**DOS RIOS WRC CHLORINE SYSTEM IMPROVEMENTS**  
**Solicitation Number: CO-00197**  
**Job No.: 17-6508**

**ADDENDUM 3**  
**September 19, 2018**

**KEY NOTES**

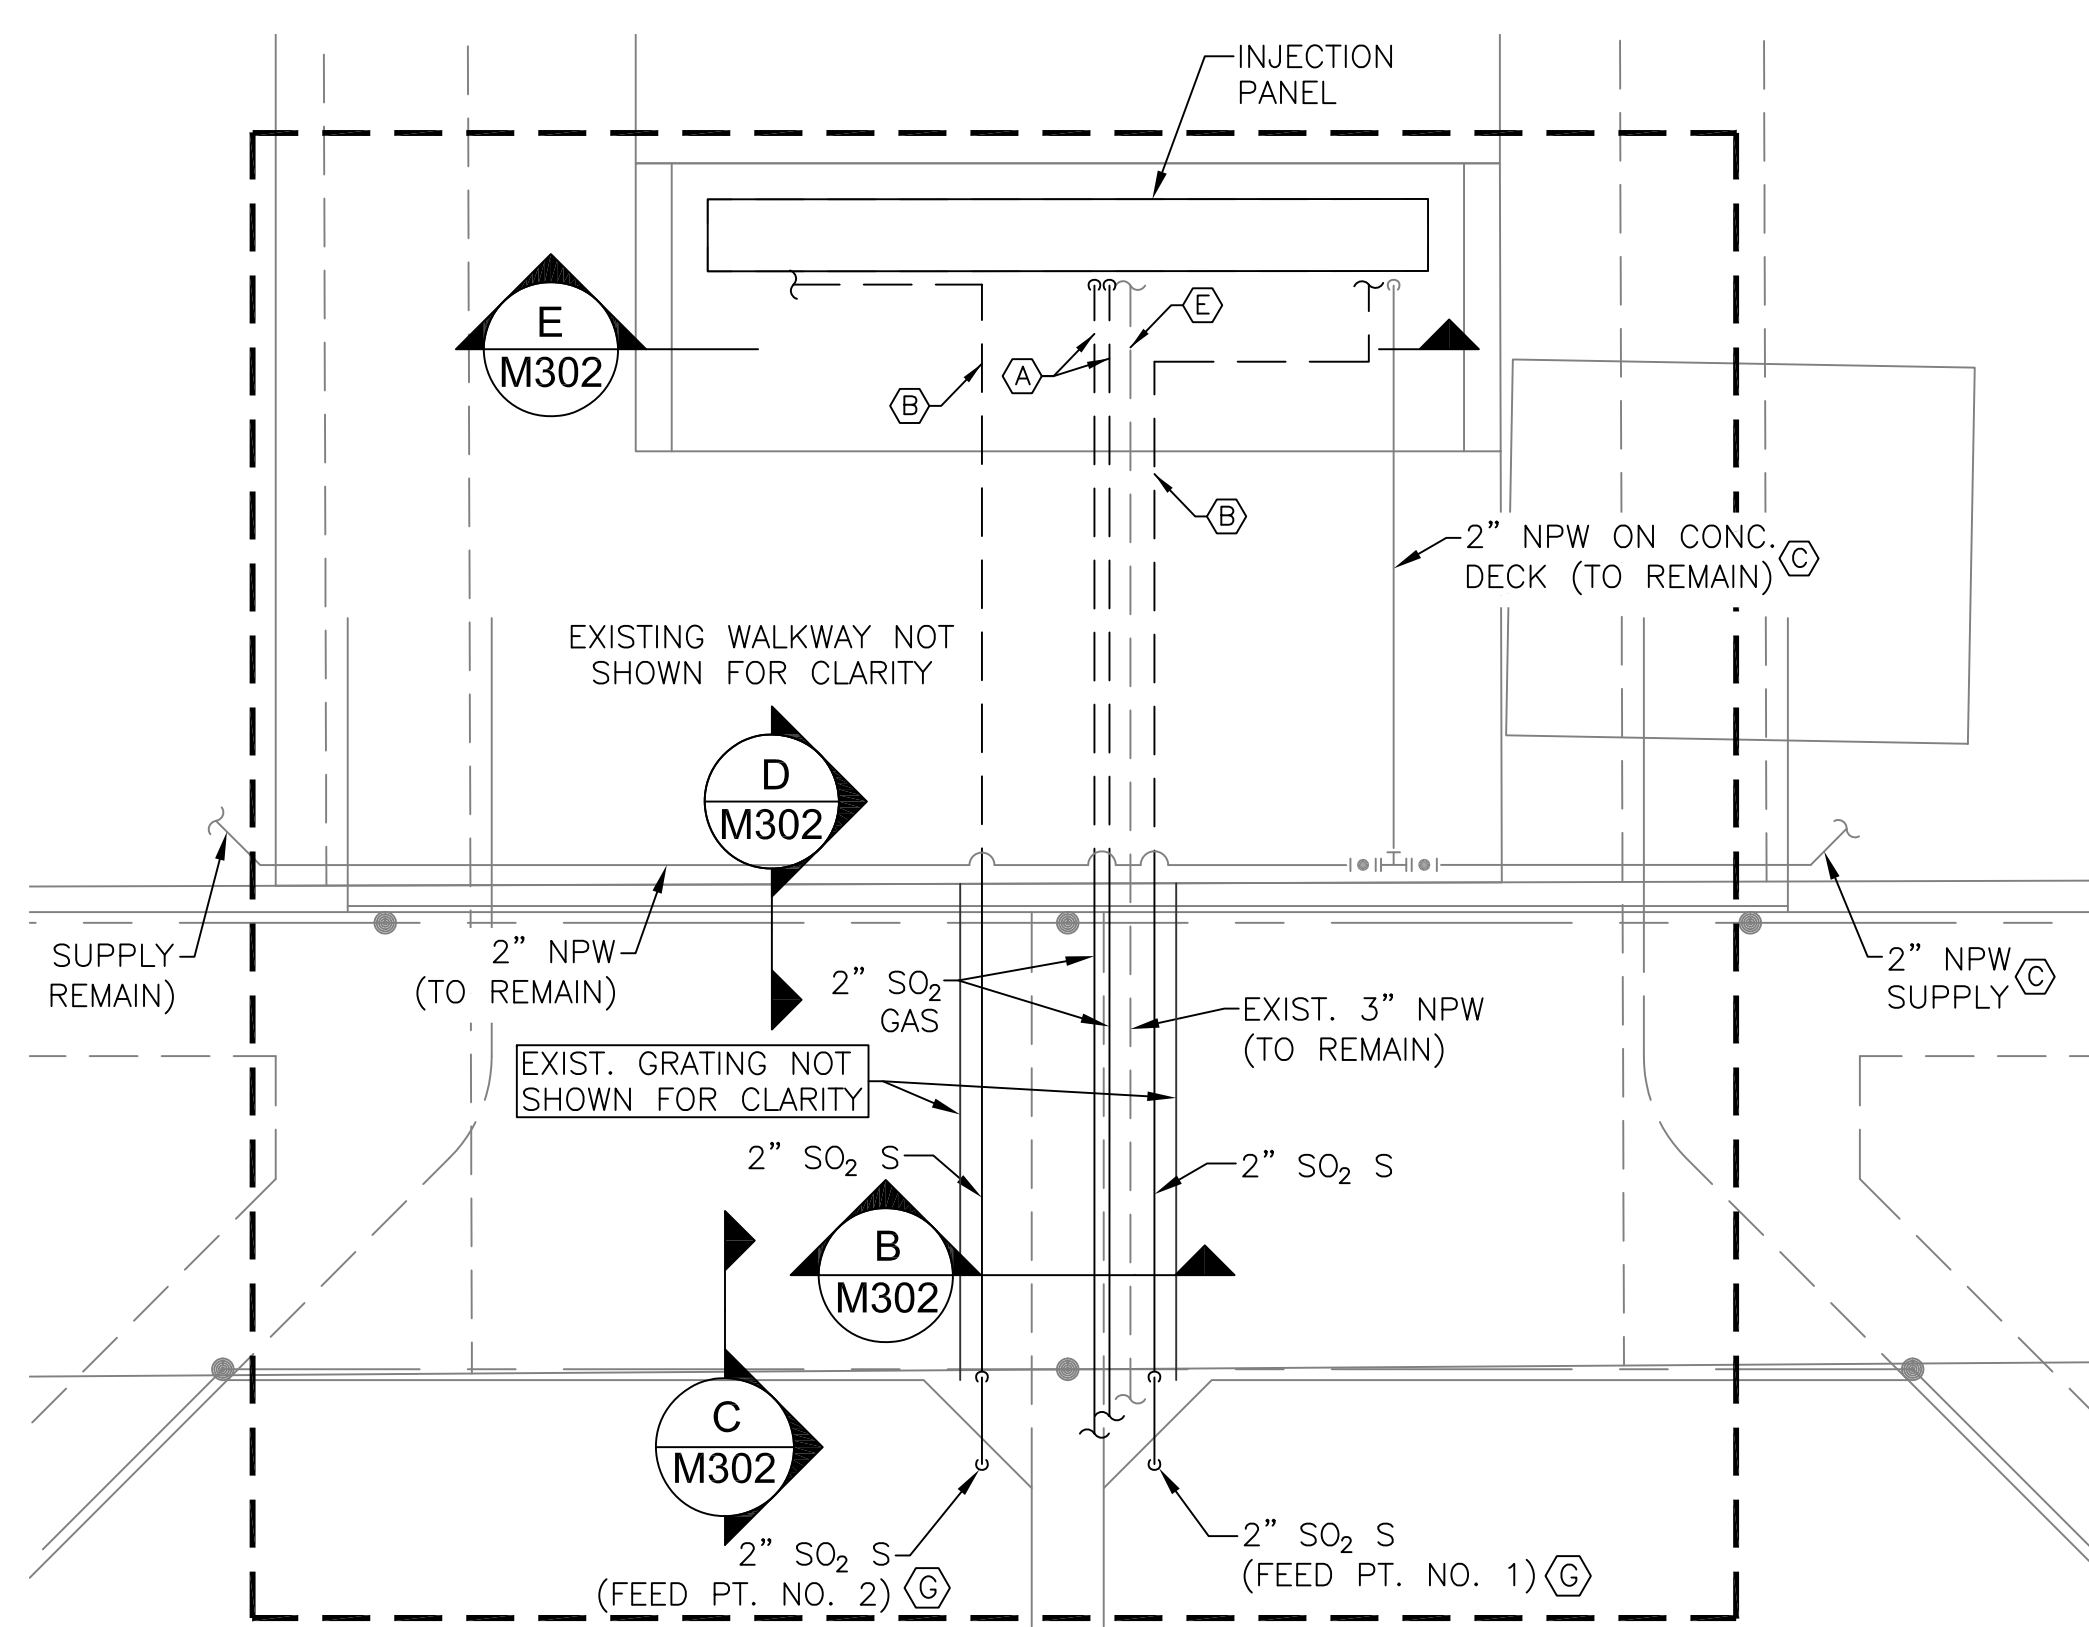
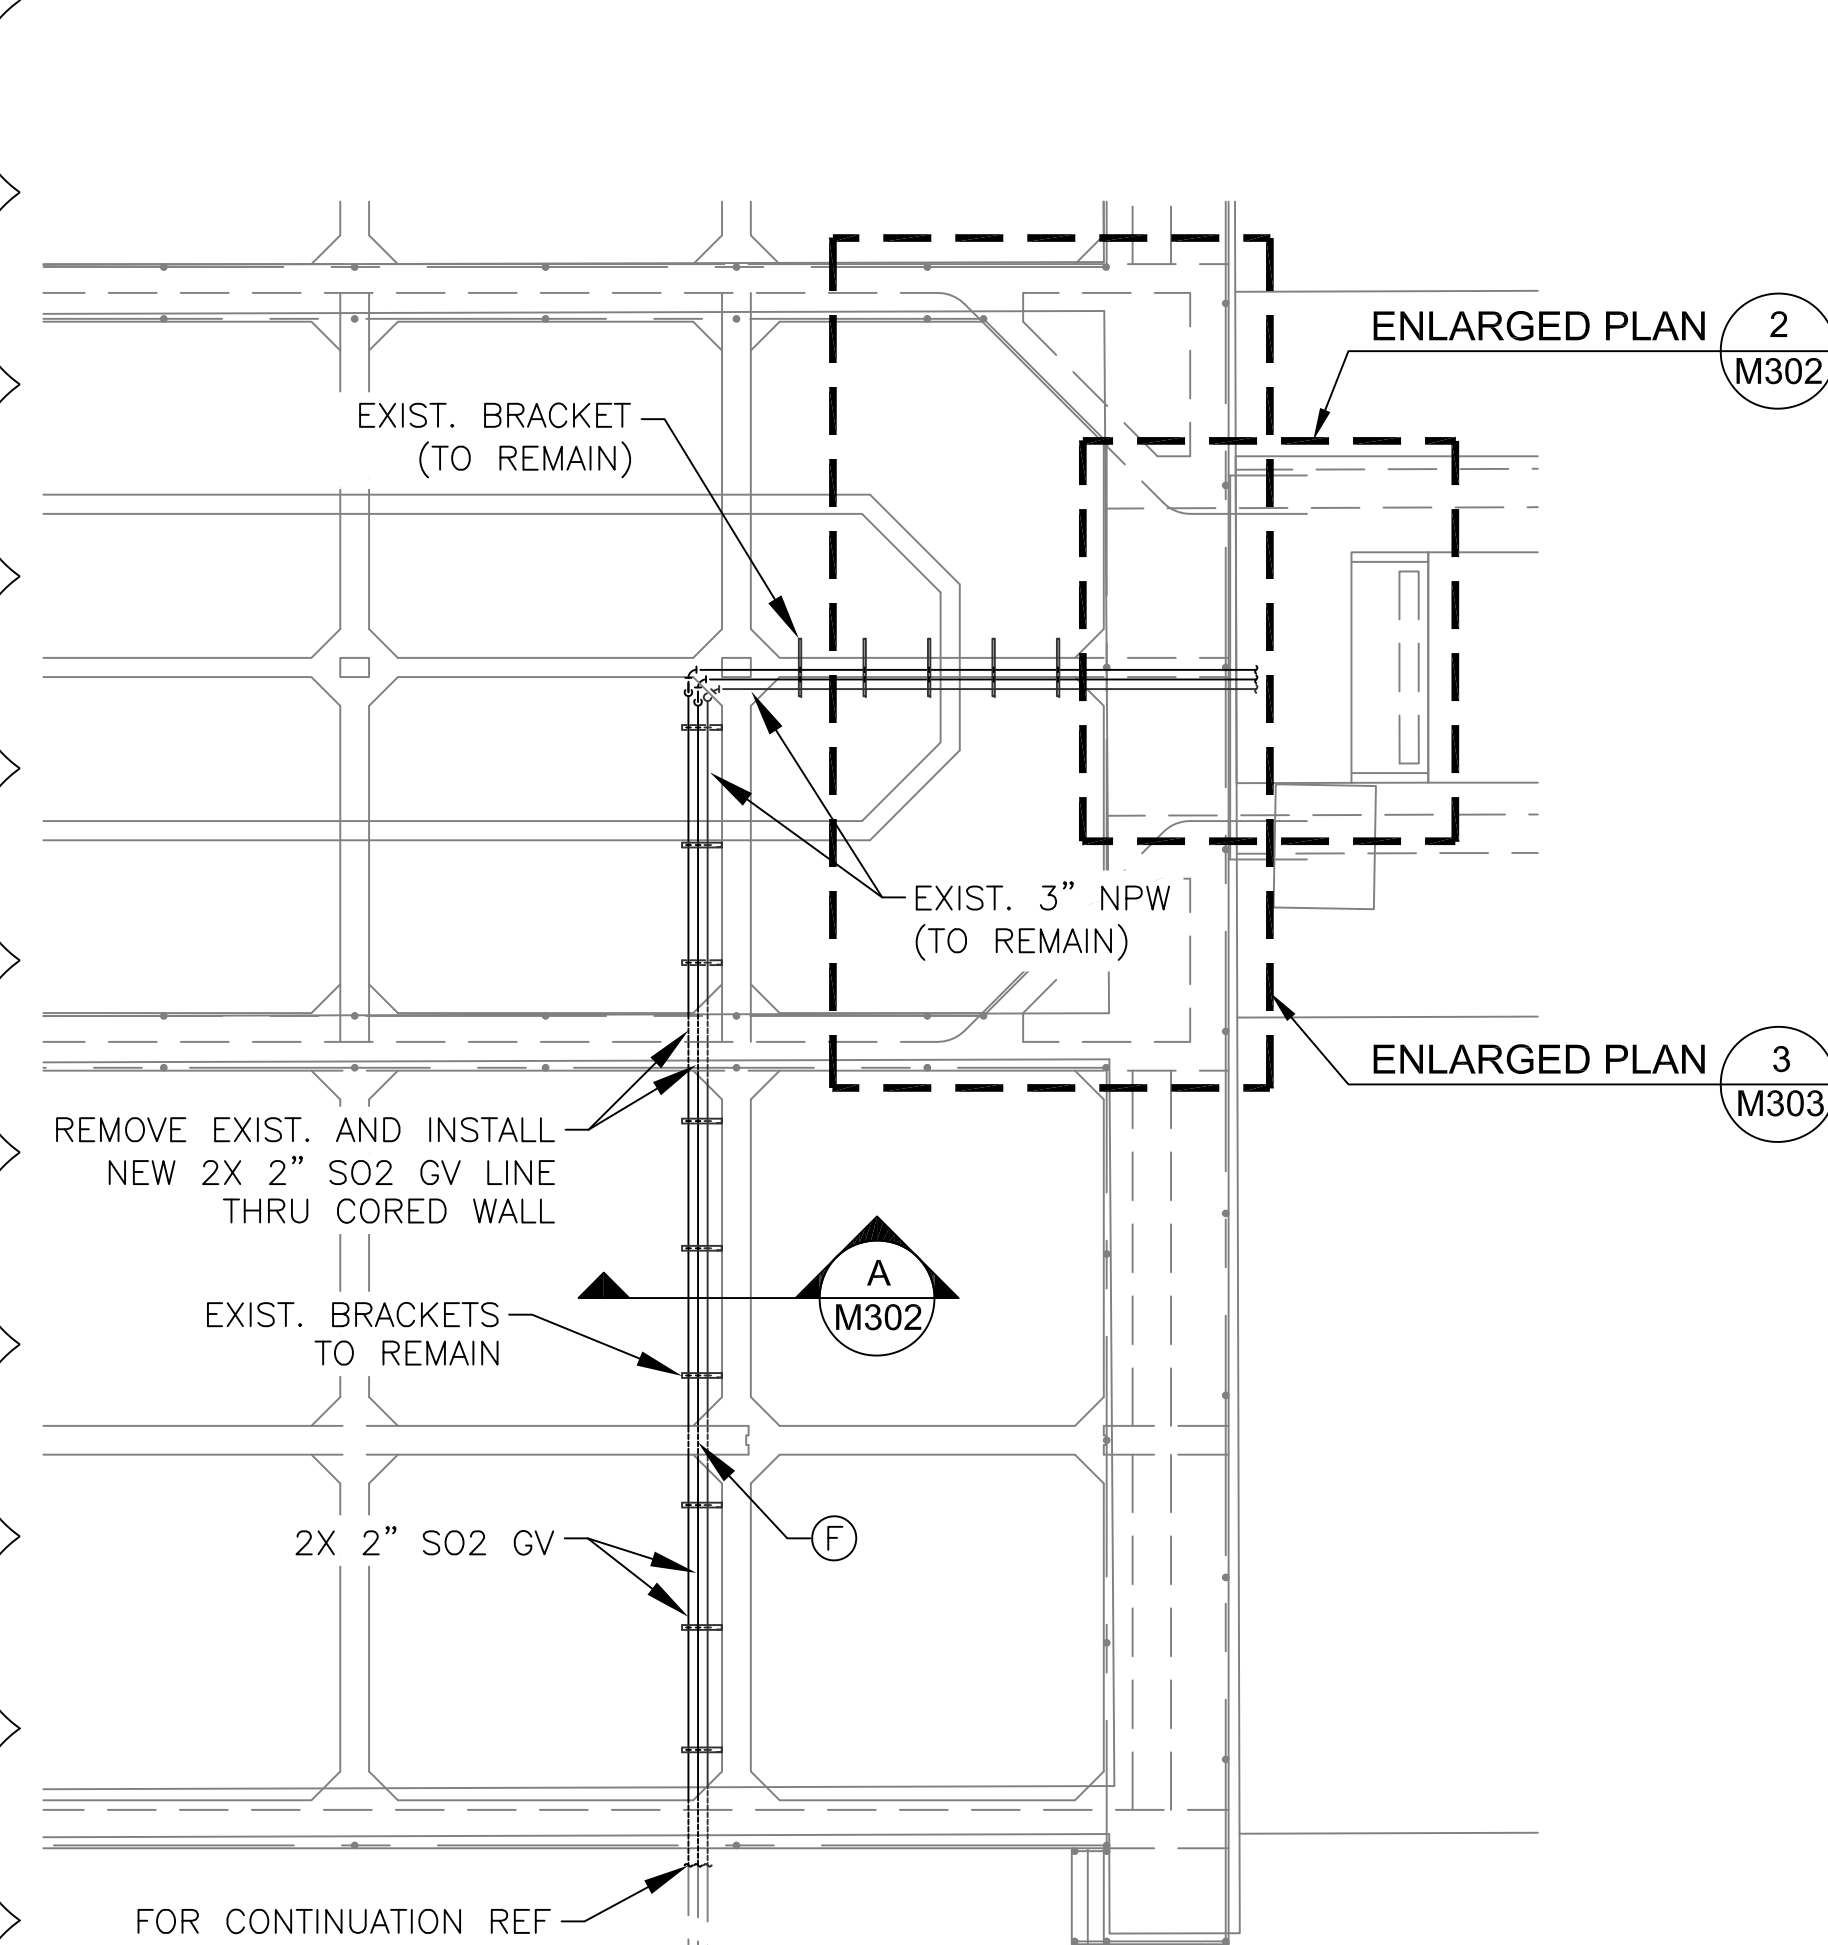
22. DWG 20-M302, Section E: Please clarify the following items:

- 45. Sheet 20-M302
  - a. Replace the sheet with the attached. Section E was modified to clarify pipe sizes at the injector panel.
- 46. Sheet 20-E133
  - a. Change reference on Detail B from "20-E134" to "20-E133"
- 47. Sheet 20-E134
  - a. Corrected scale reference bar to match the scale reference shown on the rest of the drawing.
- 48. Sheet 20-E402
  - a. Correct reference in note-by-symbol 1 text from "20-E136" to "20-E134"

Response: Refer to revised DWG 20-M302. Section view was modified to clarify line sizes, etc.
